Annex_Proposed Elevation E

Annex_Proposed Elevation A

CLIENT	Hopwood Hall College
PROJECT	Advanced Technology Centre
PROJECT NO.	20582
TITLE	Proposed Annex West and South East Navigation Elevation
DWG NUMBER	HHO-SEV-Z2-ZZ-DR-A-03044
REVISION	C05
STATUS	Construction
SCALE	As indicated @ A0
DATE	04/06/2021
DRAWN BY	SM
CHECKED BY	ZH

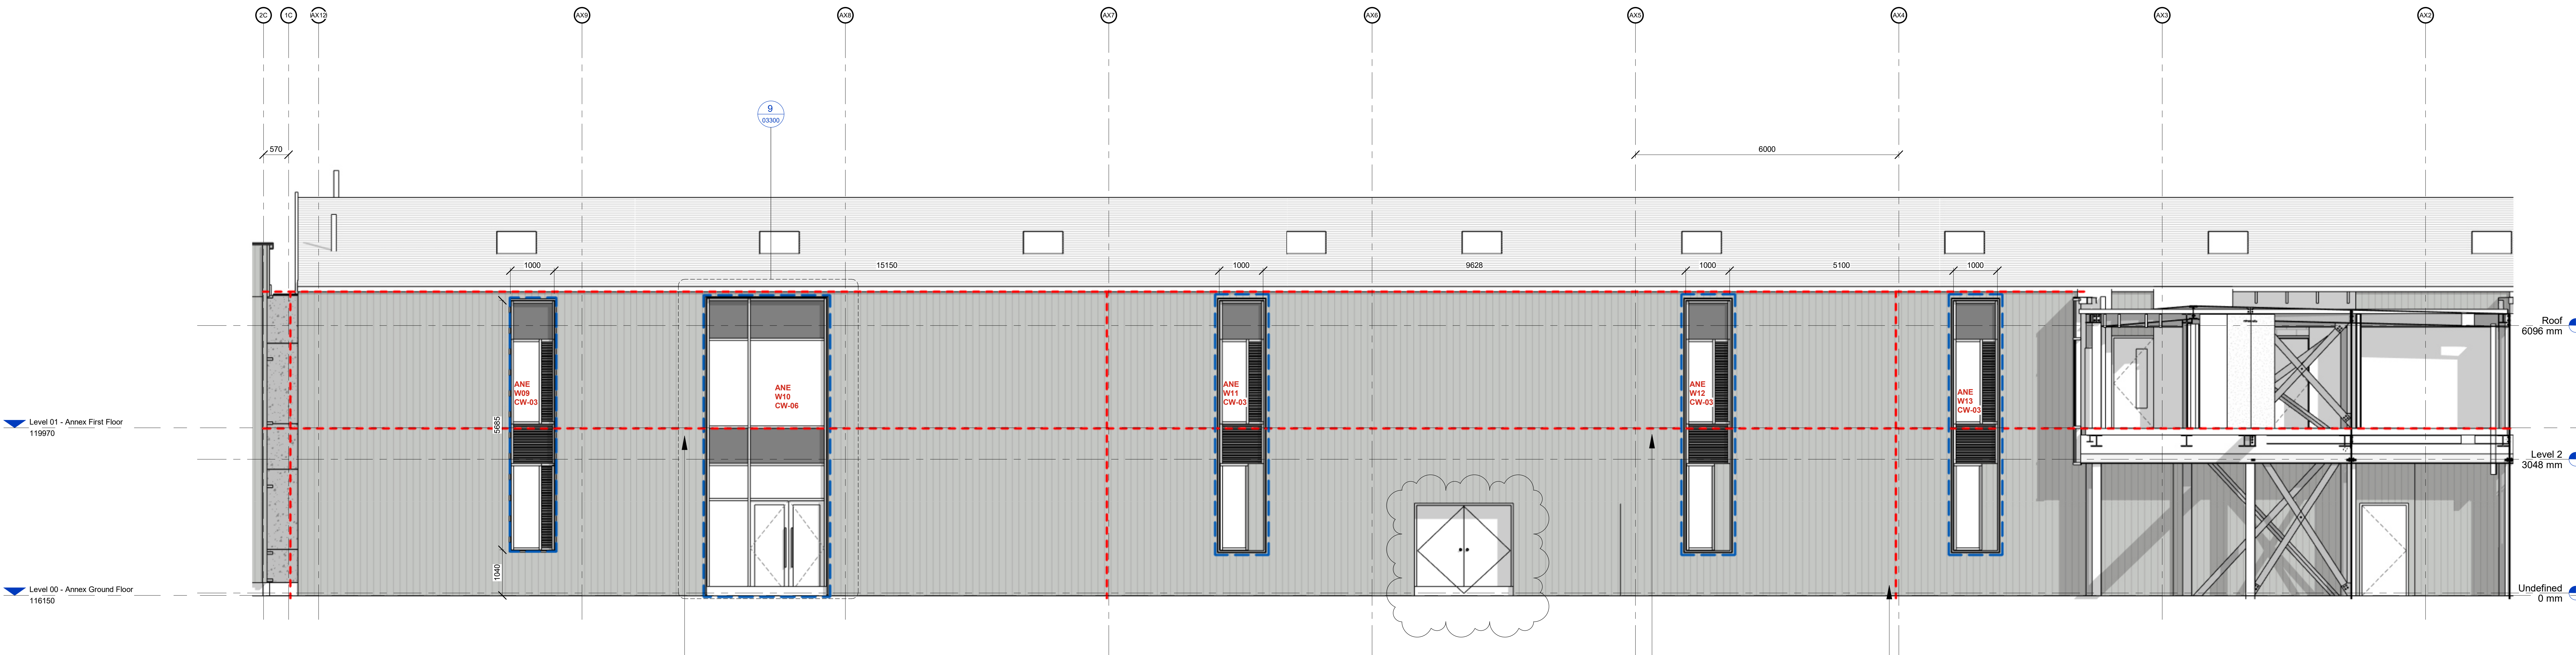
CONTRACTOR TO CHACK PRESENCE OF EXISTING FIRE BARRIERS AND PROVIDE IF NOT

WHILST THIS VERTICAL BARRIER IS SHOWN AS FR30 ON PLAN , WE SUGGEST USING THE SAME PRODUCT TO AVOID CONFUSION AND THE PRODUCTS ARE USUALLY TESTED UPTO 120MINUES ANYWAY.
